From: Brian Chadwick, 126 North Circular Road, Dublin 7, D07 K8P4

Re: CPO: Blanchardstown Bus Corridor, Case Reference: KA29N.313961

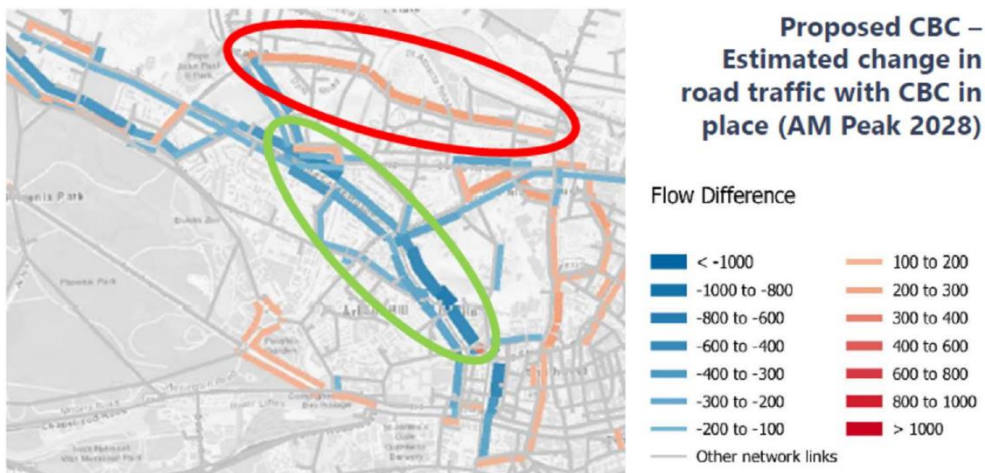
There are three road restriction changes proposed in the CPO application for the Blanchardstown Bus Corridor, none of which were set out in any of the proposed designs issued for public consultation since the Bus Connects project commenced in 2018.

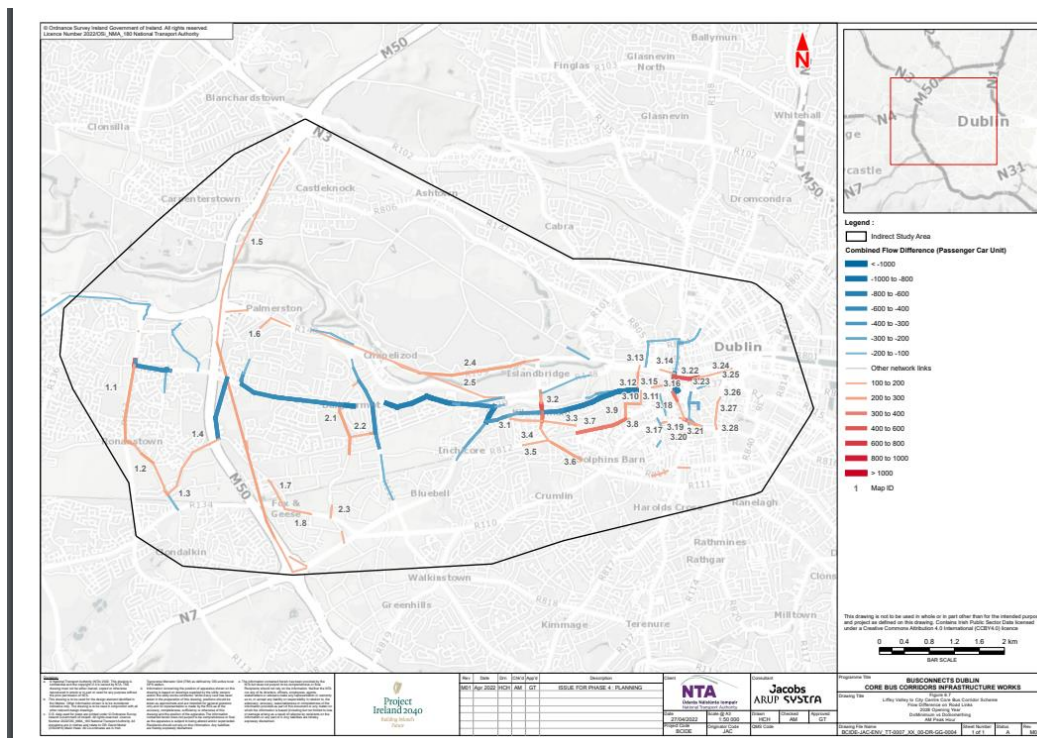
- **Flawed classification system of the impacts which sees areas forecast to experience an 80% increase in traffic flows being described as a “low impact” change.** In appendix A6.4 of the EIAR, Impact Assessments, the following are estimated when comparing a “Do Minimum” with a “Do Something” (i.e., BusConnects) scenario at PM peak hour:
 - An 80% increase in hourly traffic flows at the junction of Connaught Street and Shandon Crescent,
 - A 55% increase in hourly traffic flows at the junction of Fassaugh Ave and Dingle Road,
 - A 64% increase in hourly traffic flows at the junction of Fassaugh Ave and Bannow Road.

Each is described as having “not significant” effect and “negligible” impact. I can tell you as a regular visitor to my daughter on Connaught Street there is no way that changes of this nature can be

considered “not significant” and “negligible” in their impacts on resident’s abilities to go about their daily lives and live in a safe environment!
